Y/ref: DC7/2008/3025
Dated: 28 April 2008

Comments on Planning Application No. 7/ 2008/3025 **Extension to Agricultural Shed, Cocklakes, Penrith, CA11 0SG**

Cedric Martindale
Managing Director
CKP Railways plc

Figure 4: Model structure gauge requiring minimum associated control measures (applicable only to straight and level track)

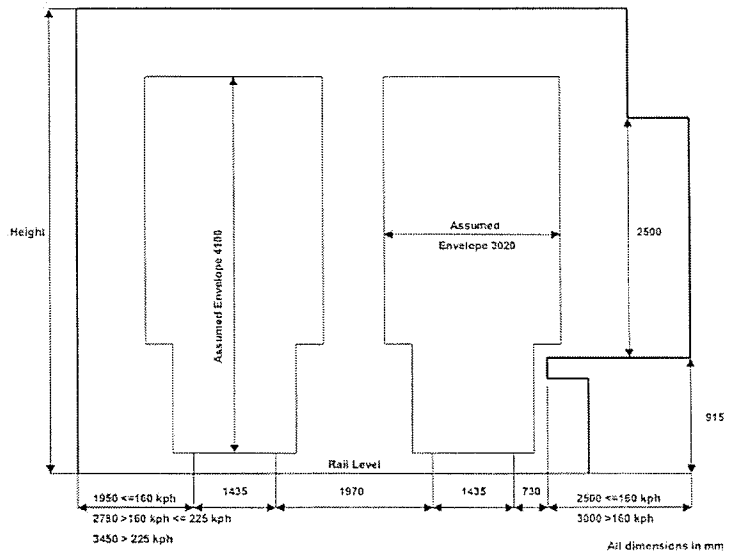
The minimum width for double track, according to the current version of this Guidance Note, is 8740 mm (actually 4370mm either side of the centre line of the existing trackbed) (calculated as 1950+1435+1970+1435+1950 mm from the attached diagram).

This in itself imposes a future maximum passing speed for trains of 160kph (100mph), which should be adequate for our purposes. Please note that the figures quoted amount to an absolute MINIMUM, not an approximation.

I would therefore ask that the "minimum required width" of the trackbed to be retained is interpreted as that width required by modern standards for trains moving at up to 100mph to pass on double track. The Standard extract attached is the basis of future requirements which we will be obliged to work to. The figure we have calculated is 4370mm either side of the centre line of the existing trackbed.
